OICA Position Paper on new 02 Series of Amendments to UN Regulation No. 138

GRBP/2024/02 and GRBP-79-34

Classification of EV's Sound Emission

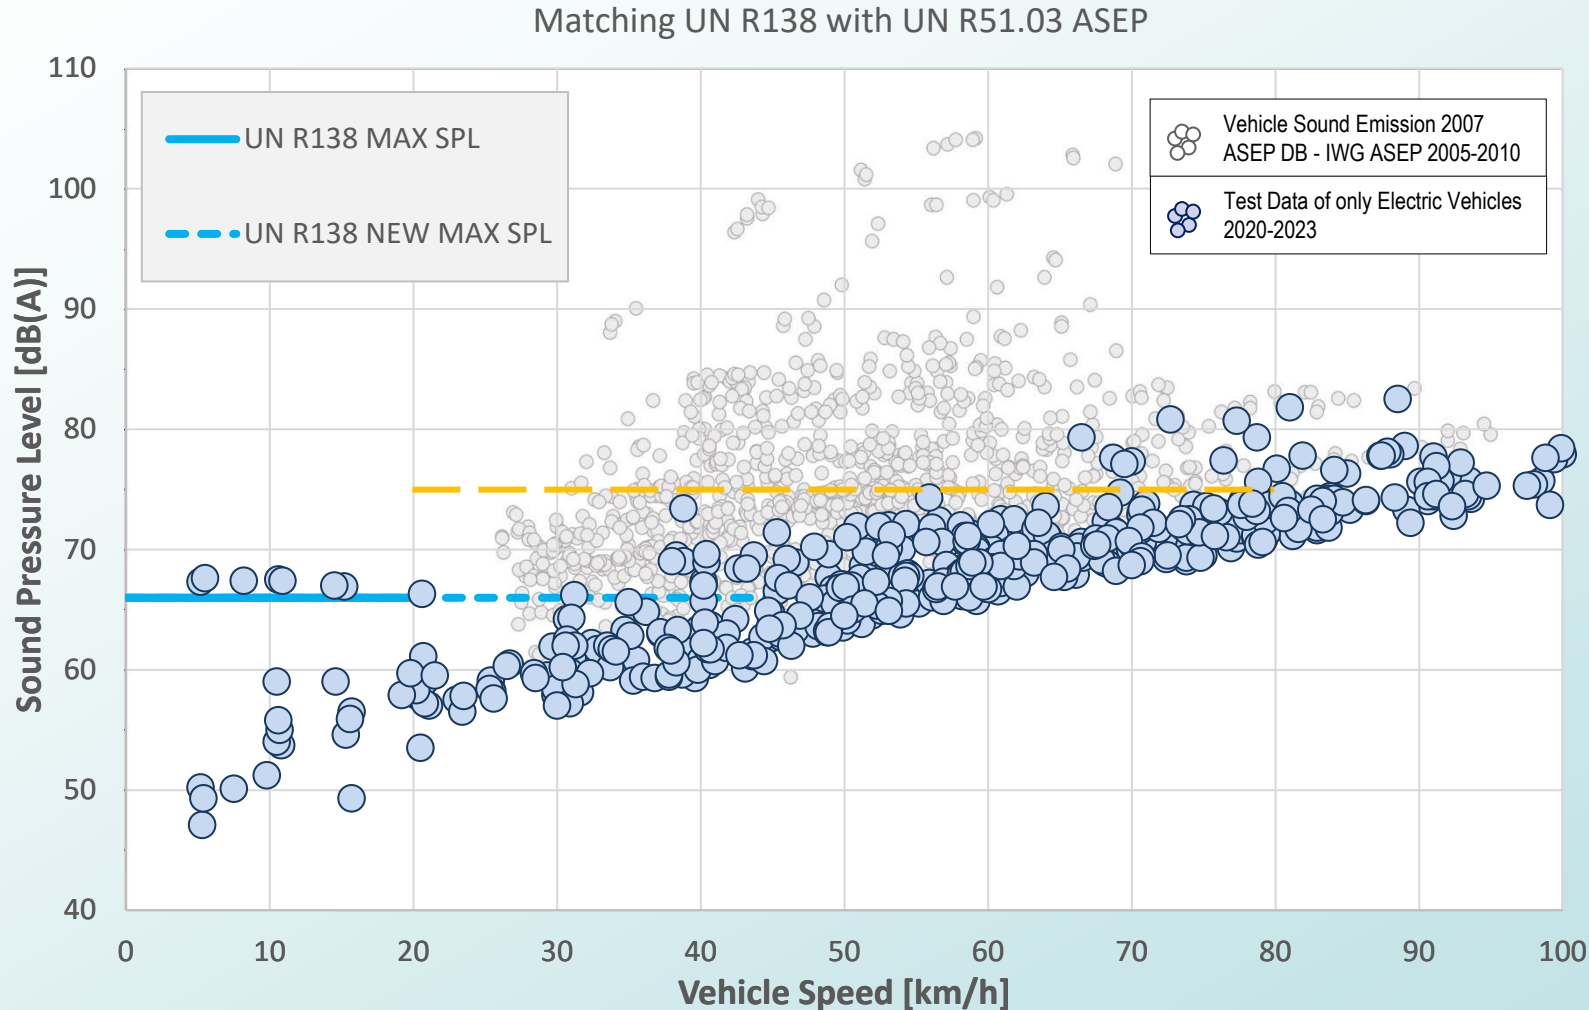
Electric vehicles have no need for stricter limits!

- EVs are **substantially below the quietest vehicle** that have been used during the ASEP development work of the years 2005-2010.
- Even when equipped **with sound enhancement systems** operating beyond the scope of UN R138.01
- OICA sees **no need for such stringent cutting of AVAS sound!**

Classification of the Sound Emission

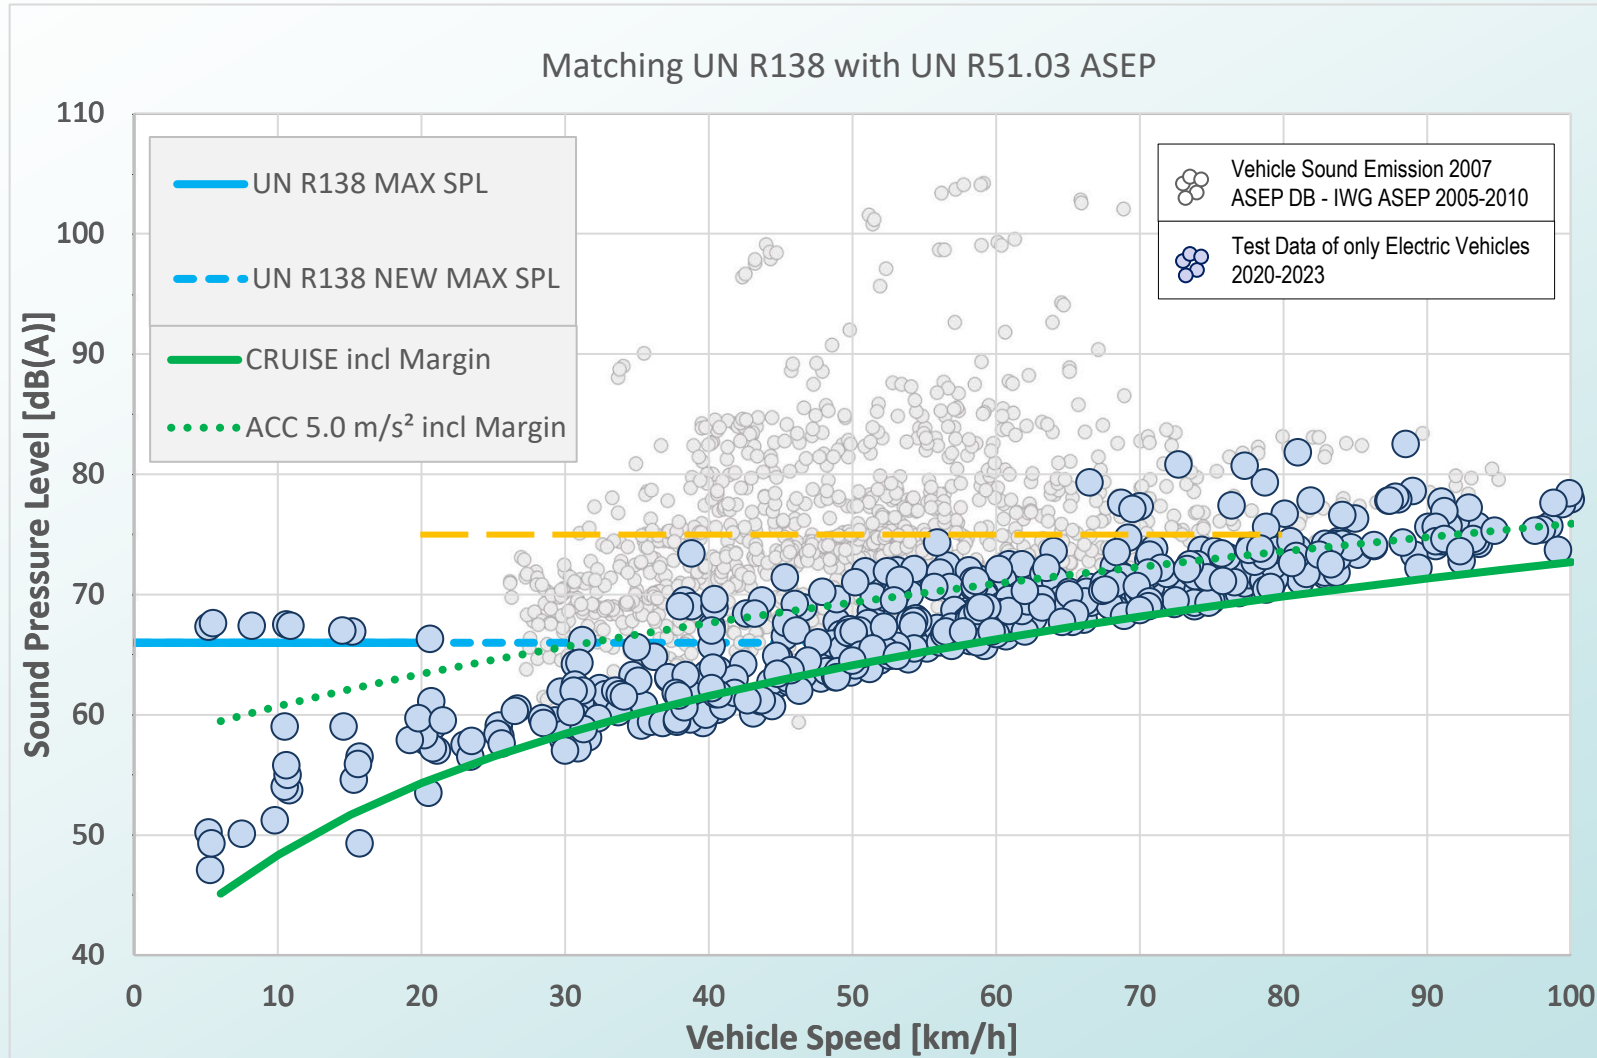
Maximum sound limits shall not jeopardize safe minimum sound!

- **“Safe Minimum Sound”** (NHTSA scientific approach*) with a safety margin of 6 dB is just reached by cruising EVs.
- Higher **“Safe Minimum Sound”** for accelerating EVs needed (see study [Perception of electric vehicles with AVAS \(udv.de\)](#))
- From 32 km/h proposed **cutting of AVAS sound will jeopardize a “Safe Minimum Sound”**

Alternative Concept for Electric Vehicles

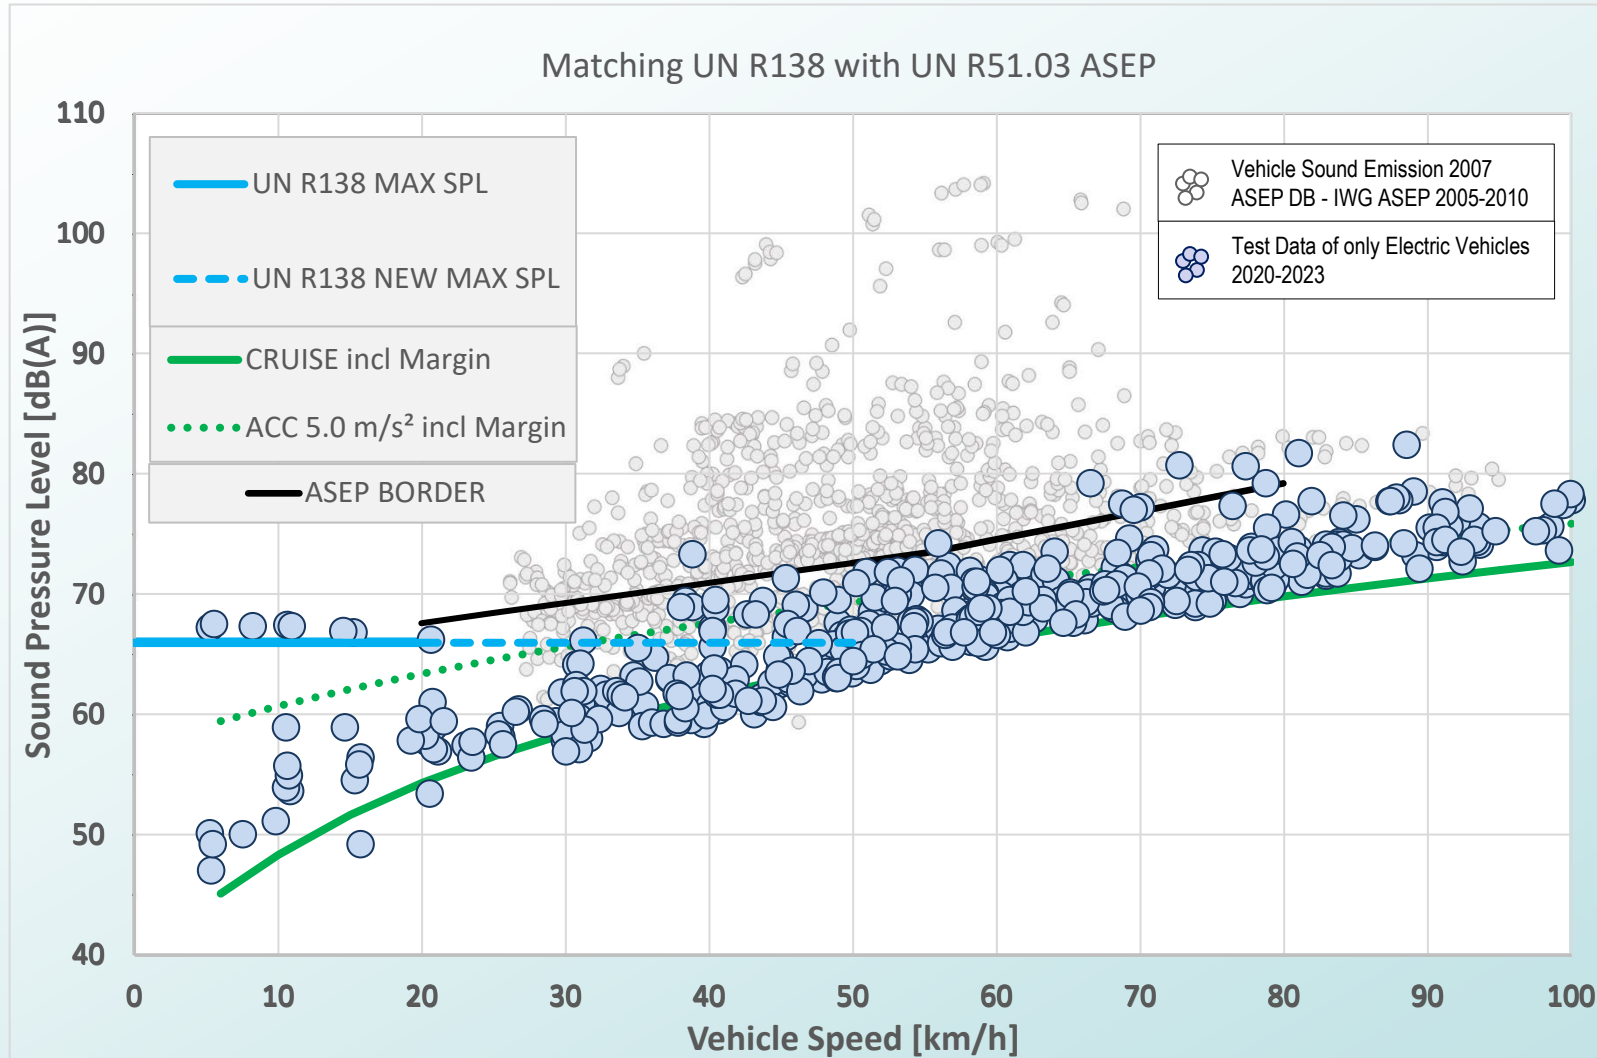
➤ OICA suggests to mandate for EVs fitted with sound enhancement systems **compliance with UN R51.03 Annex 7 ASEP provisions** (up to 80 km/h).
GRBP-79-43

Alternative Concept for Electric Vehicles

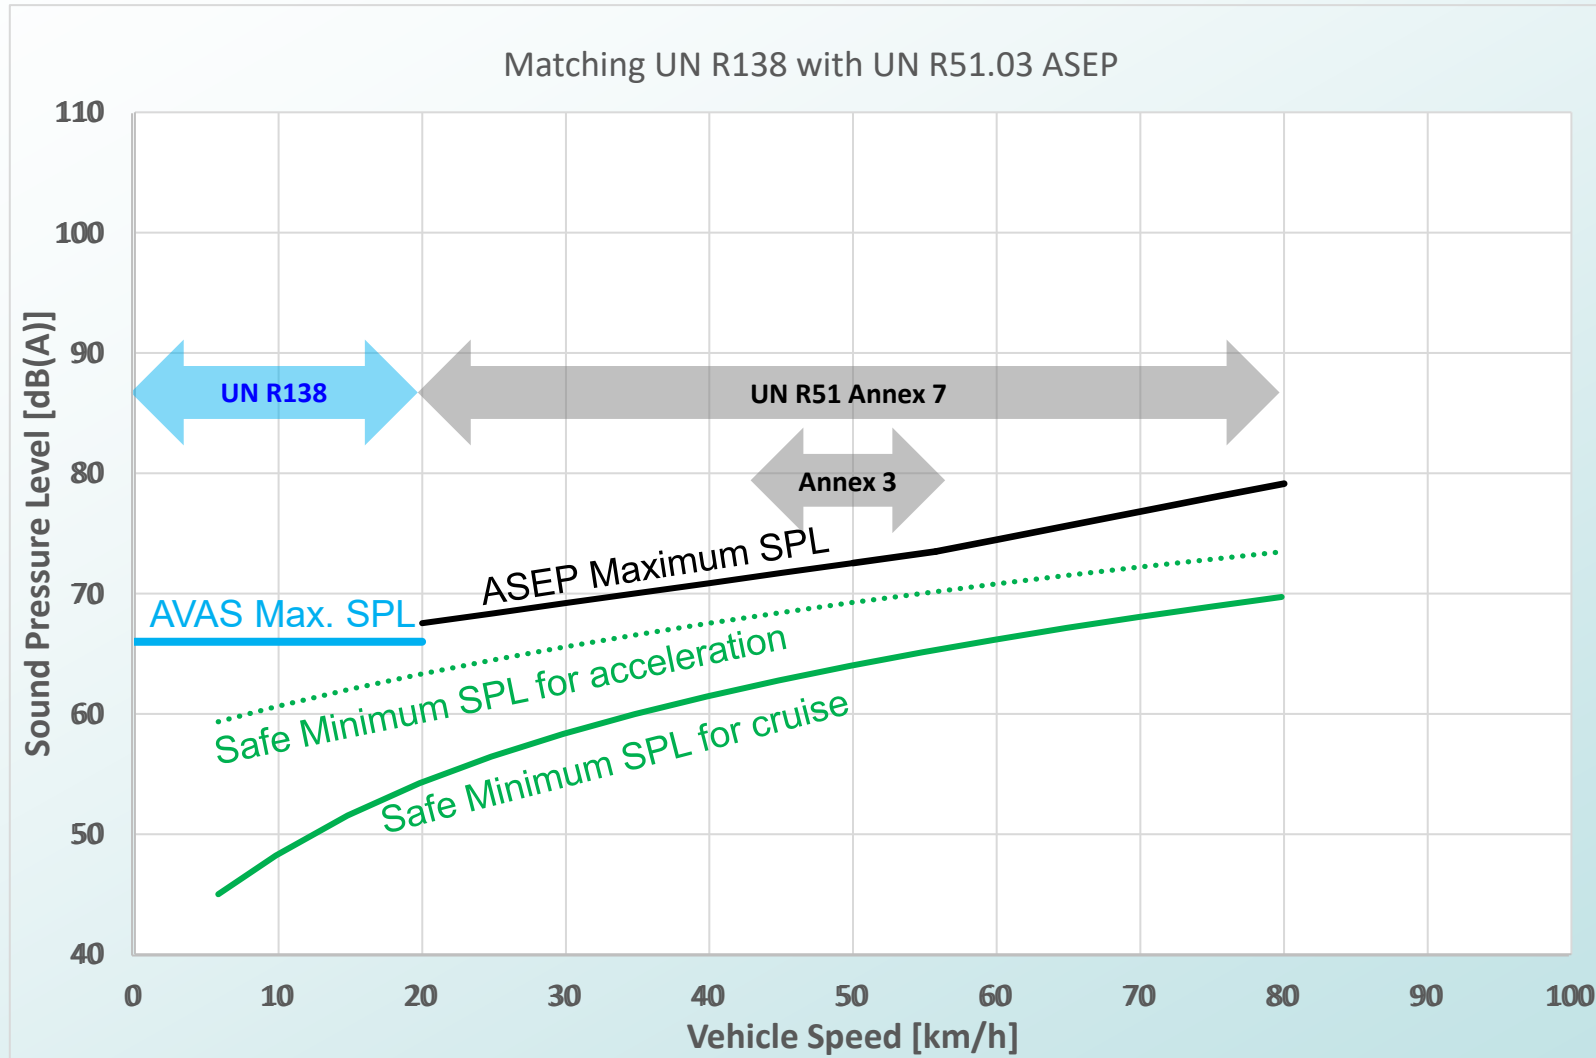
This provision will

- **connect and close any open area** between UN R138 and UN R51.
- **avoid overlapping regulations for Hybrids.**
- sufficiently **ensure**, that EVs are designed to ensure a significant **benefit**.
- welcome **your comments for improvement** and be presented as a **working document to 80th GRBP** in Sept. 2024.
